**Second Hungarian – Austrian
Bilateral Professional Workshop on
the Paks II Site Conditions**

**Short Report to the Federal Ministry for Climate Action,
Environment, Energy, Mobility, Innovation and Technology (BMK)**

REPORT
REP-0919

Date of the meeting 24.01.2023

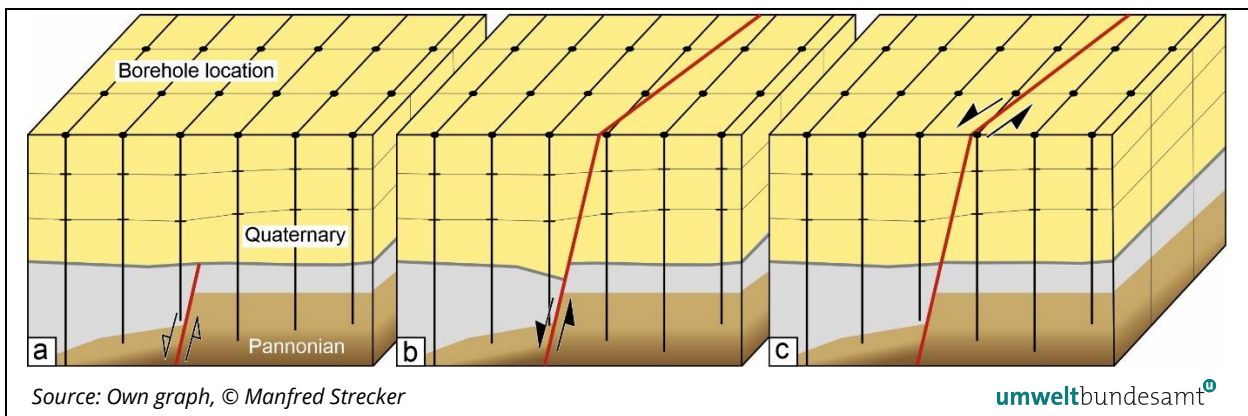
Given the kinematic history of the DHFZ and the offsets of Quaternary sediments recorded along other faults in the region it is likely that similar small offsets at decimeter scale cannot be detected in geological profiles constructed solely with borehole information (Figure 1). Likewise, offsets in Quaternary sediments would be virtually impossible to verify by drilling if the Quaternary kinematic style has been characterized by strike-slip faulting. In combination with the currently available database this uncertainty could only be resolved by paleoseismological trenching.

The EAA experts consequently reiterate their suggestion to consider comprehensive paleoseismological investigations of the excavation pit with the aim to

prove the non-existence of capable faults below the future base mats of the reactor buildings and other safety-related engineered structures. Such decision would be a way forward toward a better overall understanding of the site, and it would be in line with IAEA, WENRA, national requirements in other countries, and the current state of science and technology.
